**Butte Priority Soils Operable Unit (BPSOU) Draft Final Insufficiently Reclaimed Sites - Field Sampling and Investigation Plan (FSP)
BRES No. 08 – Belle of Butte**

RE: Butte Priority Soils Operable Unit (BPSOU) Draft Final Insufficiently Reclaimed Sites - Field Sampling and Investigation Plan (FSP) BRES No. 08 – Belle of Butte.

Re: Butte Priority Soils Operable Unit (BPSOU) Revised Draft Final Insufficiently Reclaimed Sites - Field Sampling and Investigation Plan (FSP) BRES No. 8 – Belle of Butte

Figure 1. Insufficiently Reclaimed Sites IR-08 Belle of Butte Proposed Sample Stations

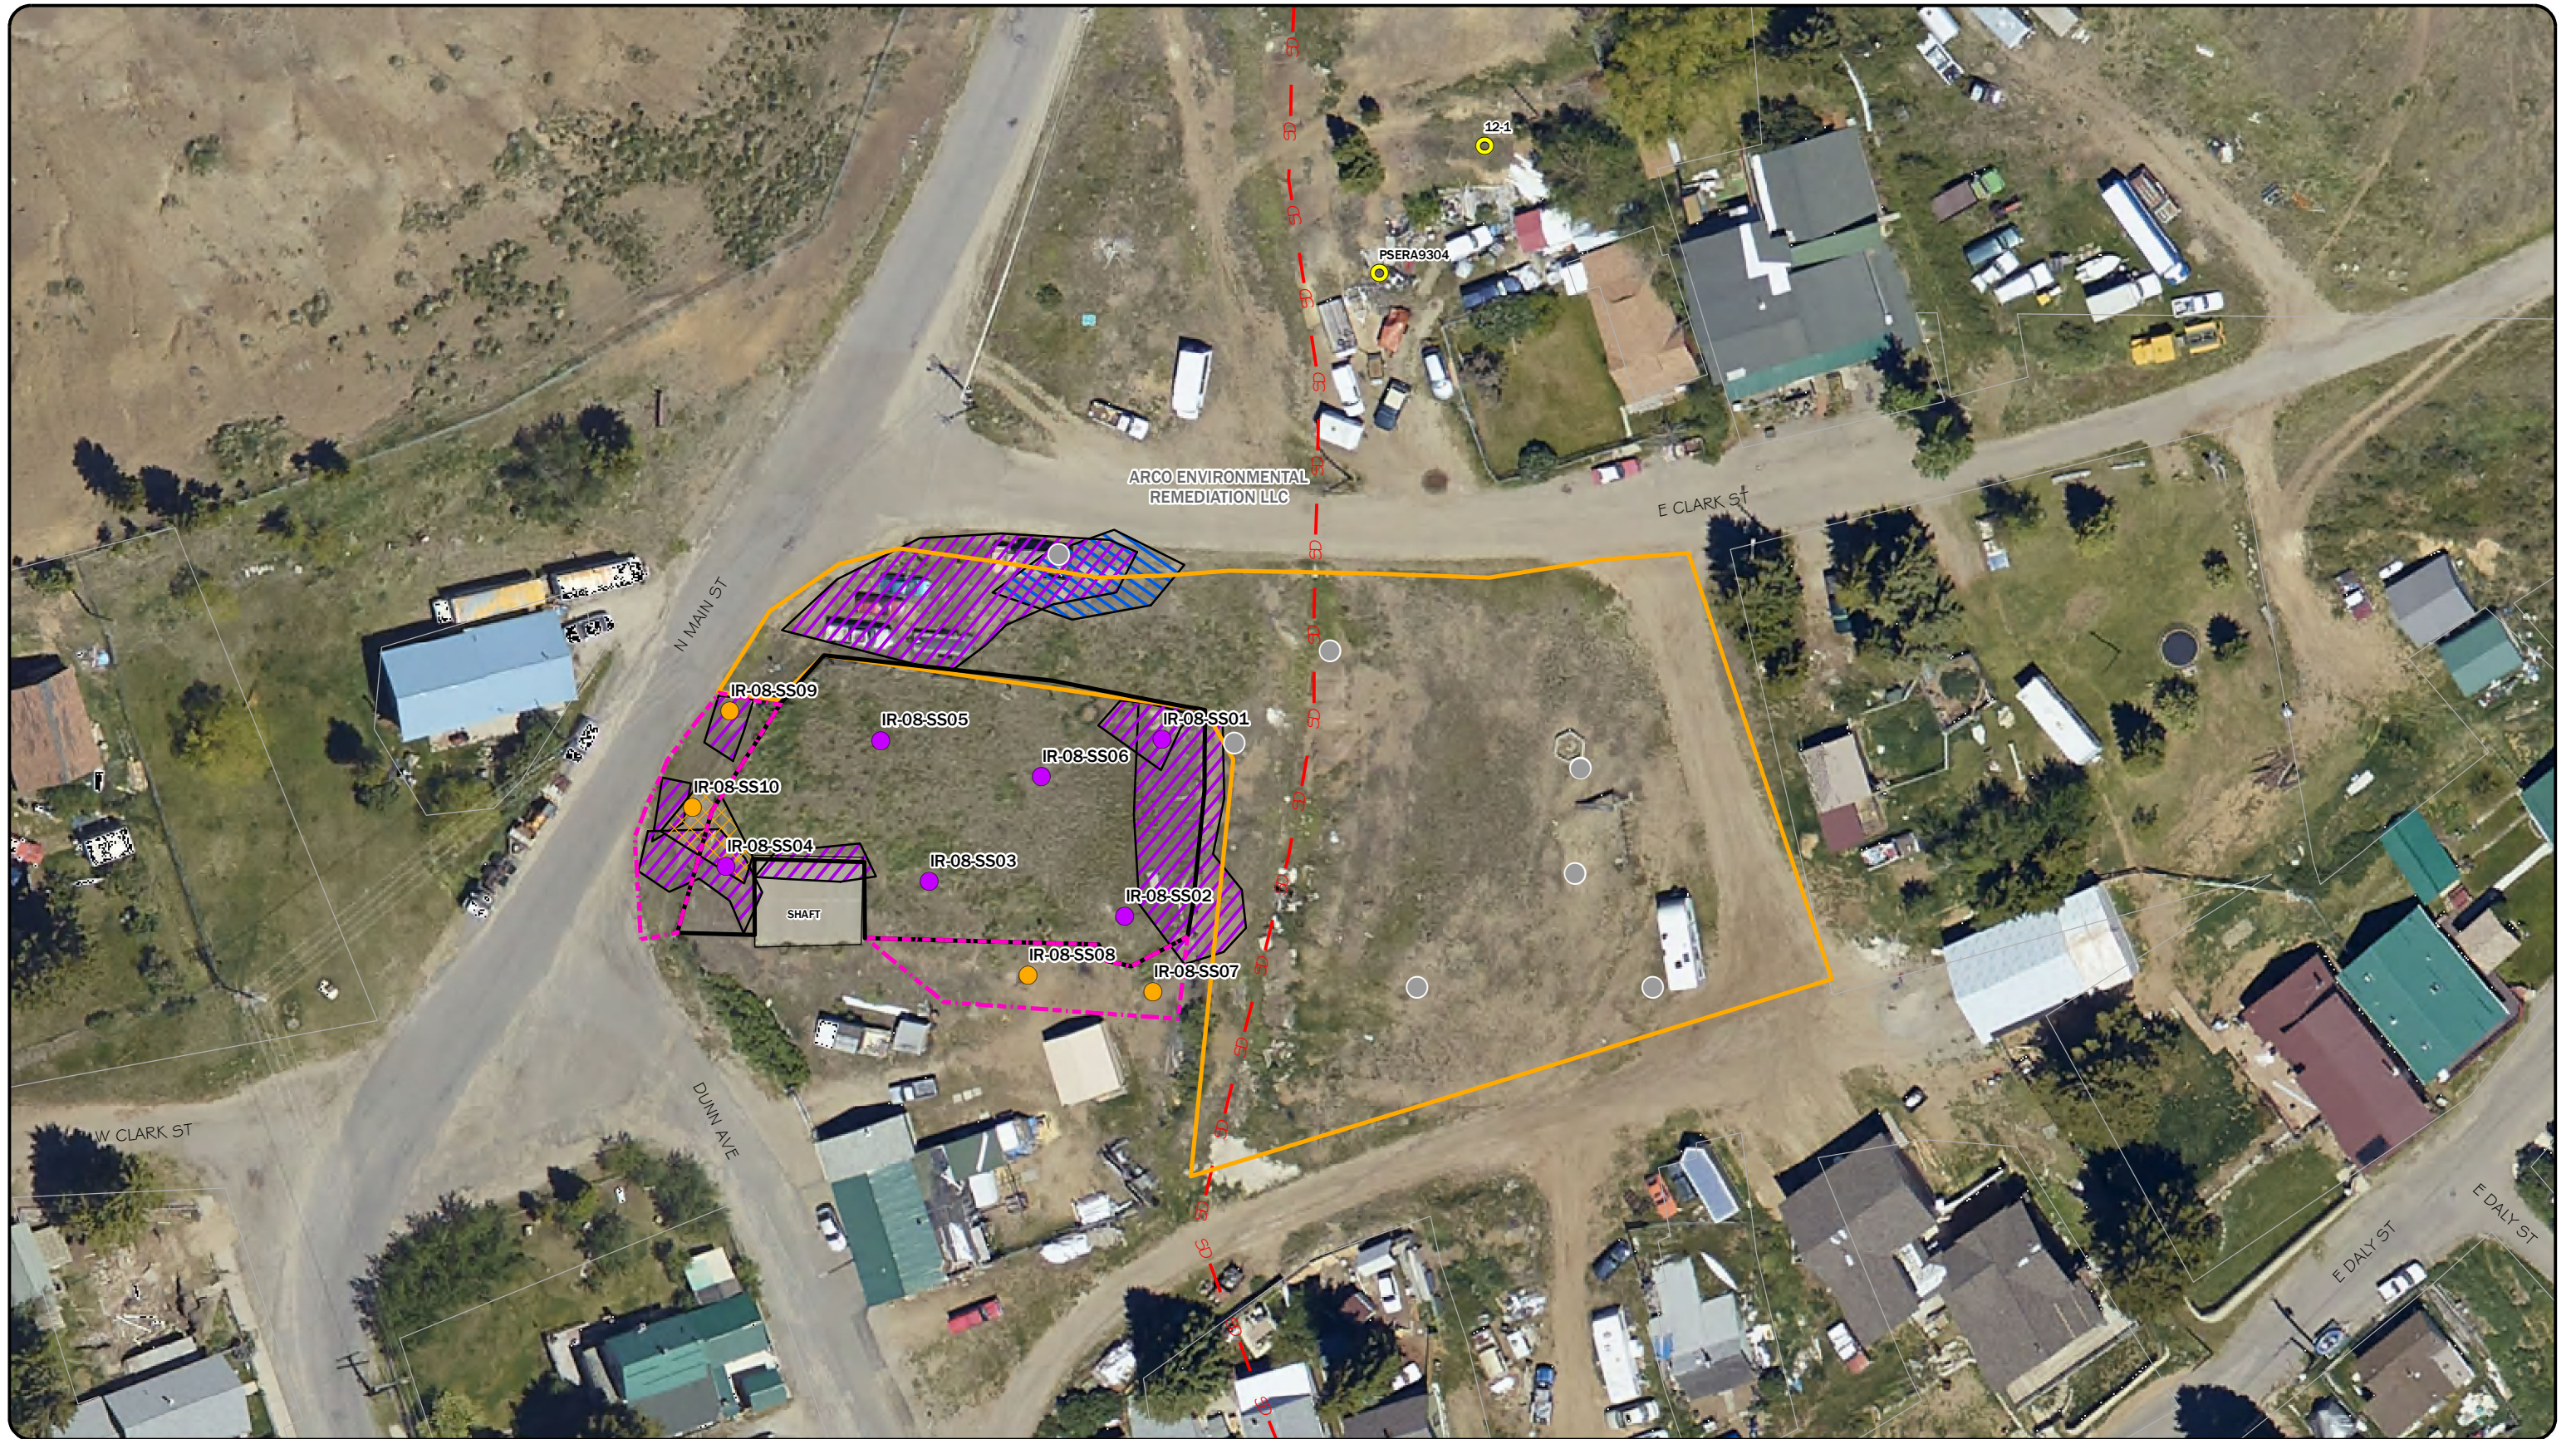
1. *Please confirm the boundary for BRES No.08 as depicted on Figure 1 of the FSP. What is believed to be the correct boundary for the site is shown in the figure below. As required, please correct the boundary on Figure 1 as appropriate or clarify the boundary discrepancy.*

2. *Please clarify the inclusion of proposed unreclaimed sample locations for UR-39 depicted on Figure 1 of this FSP.*

Atlantic Richfield Company Response: The boundary referenced in the Agency comment is the original BRES No. 08 boundary. Figure 2 (attached) included in the revised FSP displays the new BRES No. 08 reclaimed area boundary which is consistent with Figure IR-1 included in the CD FRESOW.

Atlantic Richfield Company Response: The Unreclaimed Site UR-39 boundary and proposed 2021 sample locations were included on Figure 1 to show that the northern portion of the original BRES No. 08 boundary was sampled and characterized in the 2021 Unreclaimed Sites sampling event. Sampling is complete, and the legend has been updated to reflect the 2021 Unreclaimed Sampled Stations.
